DART AEROSPACE LTD	Work Order:	150962
Description: Crosstube Assembly (AS350/355 High Fwd SS)	Part Number:	D350-748-143
Inspection Dwg: D350-748-143 Rev: A		Page 1 of 2

DART AEROSPACE LTD HAWKESBURY, ONTARIO, CANADA	
DRAWING NO. D350-748-143	REV. A SHEET 1 OF 4
TITLE CROSSTUBE (AS 350/355 HI FWD)	SCALE NTS

DRAWING NO. D350-748-143	TITLE CROSSTUBE	REV. A	DART AEROSPACE LTD ENGINEERING ORDER		D.E.O. NO. D350-748-143-A-1	SHEET NO. SHEET 1 OF 1	SCALE NTS
DRAWN <i>JP</i>	CHECKED <i>ASS</i>	MFG. APPR. <i>[Signature]</i>	APPROVED <i>[Signature]</i>		DE APPR. <i>[Signature]</i>		
DATE 15.11.18	DATE 15.11.18	DATE 16.02.19	DATE FEB 19 2016		DATE 2016.02.19

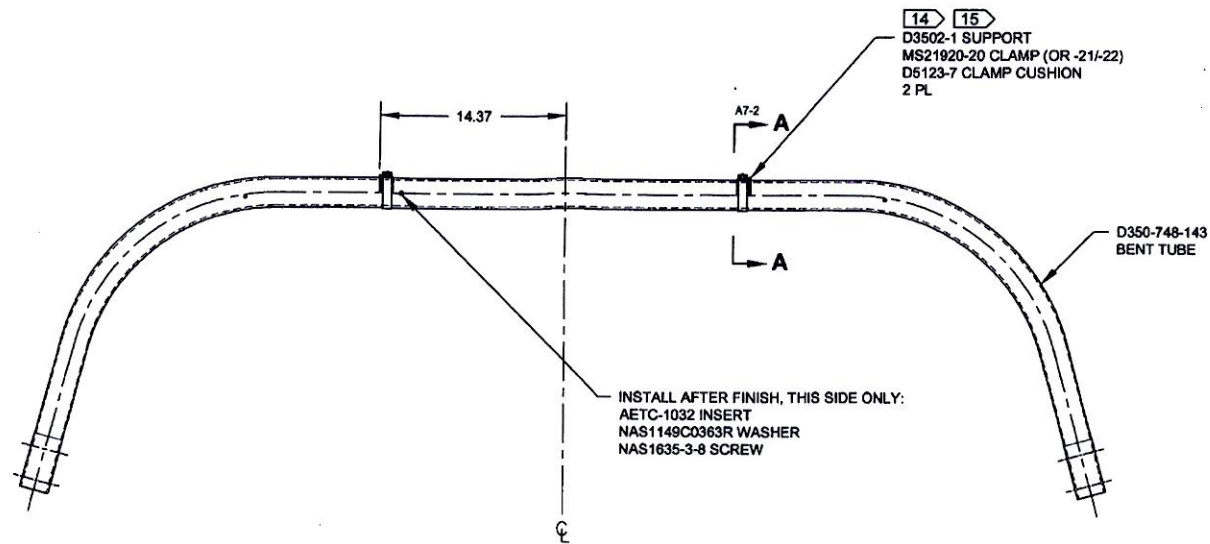
AMEND NOTE 2 (SHEET 1) AS FOLLOWS:

- 2) FINISH: PREPARE SURFACE PER DART QSI 005 4.1.4
 PRIME INSIDE AND OUTSIDE PER DART QSI 005 4.2
 PAINT OUTSIDE PER DART QSI 005 4.2
 OR
 POWDER COAT WHITE (4.3.5.2) PER DART QSI 005 4.3
